GEOCRES No. 30M13-141DIST. CR REGION                     W.P. No.                     CONT. No.                     W.O. No. 96-11001STR. SITE No.                     HWY. No. 400LOCATION Sewer Crossing  
City of VaughanNo. of PAGES -                     =====OVERSIZE DRAWINGS TO BE INCLUDED WITH THIS REPORT.                     REMARKS:

**GEOTECHNICAL INVESTIGATION AND BASELINE  
TWIN TUNNELED STORM SEWERS  
VELORE WOODS AND HIGHWAY 400  
VAUGHAN, ONTARIO**

**RE: RESPONSE TO MINISTRY OF TRANSPORTATION (MTO)  
REVIEW COMMENTS  
TWIN TUNNELLED STORM SEWERS  
VAUGHAN, ONTARIO**

FIGURE 3

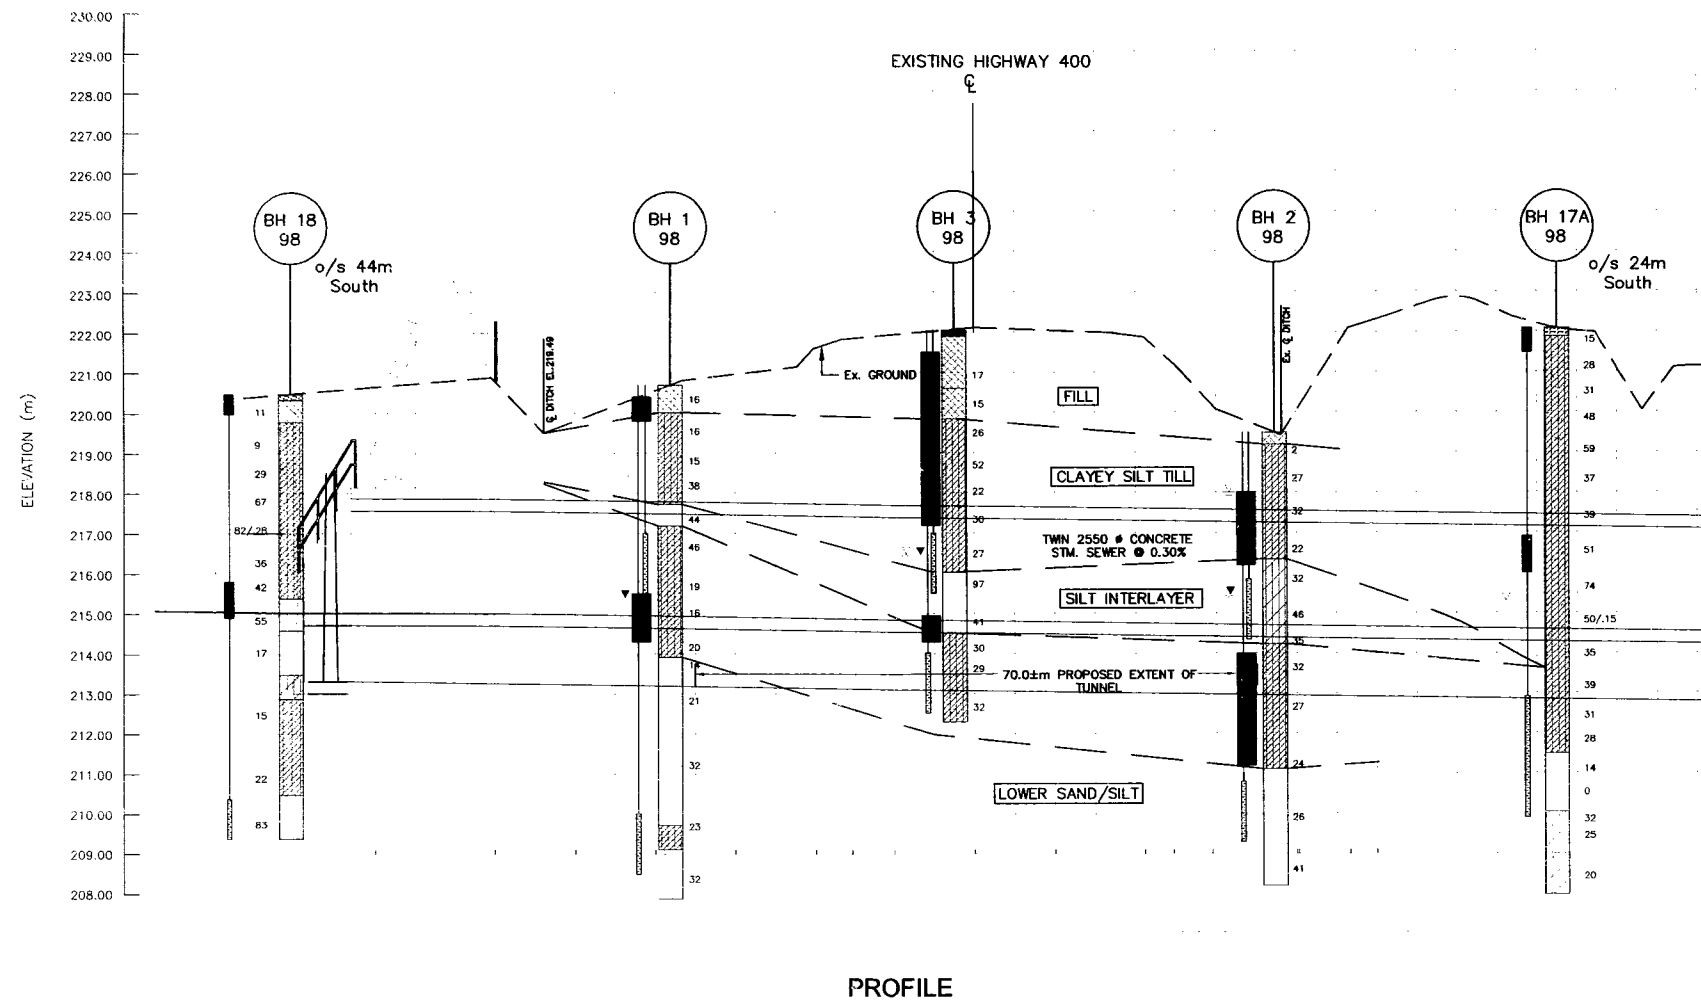
**Structural Issues ①** This comment indicated an apparent discrepancy between the geotechnical report (Golder Associates Report 981-1179 dated January 1999) and the contract submission. The report assumed the tunnels were to be 6 m apart centre-to-centre and the contract submission apparently indicated a spacing of 5 m centre-to-centre. As indicated under Geotechnical Issues ① it is now understood that the tunnels will be spaced at 9 m centre-to-centre. The recommendations of the geotechnical report do not need to be altered for the proposed wider spacing.

Part one of this comment concerned the spacing of the tunnels which in our report were assumed to be 6 m centre-to-centre. For this configuration we undertook an assessment of potential ground surface settlement and settlement patterns. This assessment suggested that there would be minimal overlap between the settlement troughs induced by the two tunnels; this conclusion is in part a function of the somewhat limited cover above the tunnels. However, there are uncertainties in such settlement assessments and the risk of the settlement troughs overlapping significantly would be reduced by increasing the centre-to-centre spacing. Further, we understand that there are not significant cost or property implications for increasing the spacing on this contract. Therefore, it is recommended that the tunnel spacing be increased to 9 m centre-to-centre, as suggested by MTO.
